From: Caneparo Associates

Job Title: 13 Fitzroy Street

Subject: Transport Note: Disabled Parking

Figure 1: Disabled Parking Bay Locations (On-street)

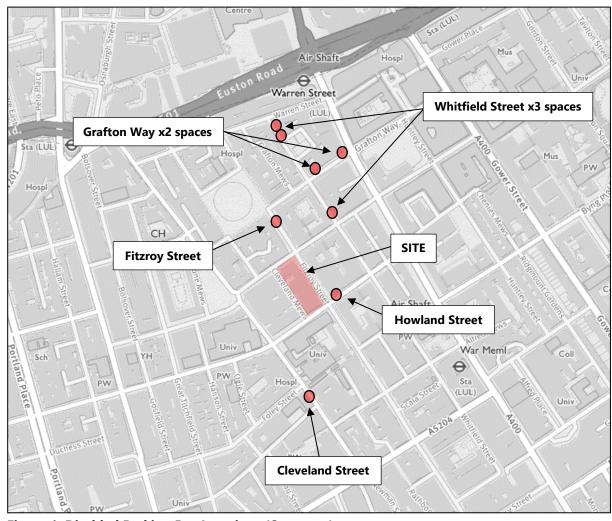
The number of such spaces is unclear. I suggest you ask the applicant to provide further commentary on the justification for the loss of disabled parking spaces. I am not sure this would be supported by the

Council's access officer. I also suggest you ask the applicant to suggest alternative locations nearby

where blue badge holders could park (i.e. on-street parking bays on Fitzroy Street)".

- 11. **Figure 1** highlights 8 disabled parking spaces within a 300m walking distance from the Site. It is considered that these disabled parking spaces are capable of accommodating any future demand that may arise from the proposed office development for disabled parking.
- 12. The Site is located within Camden's Green Badge Zone which not only requires drivers to have a blue badge to park within disabled parking spaces, but also to:
 - Live in Camden in the green badge area
 - Work in Camden (full or part-time) in the green badge area
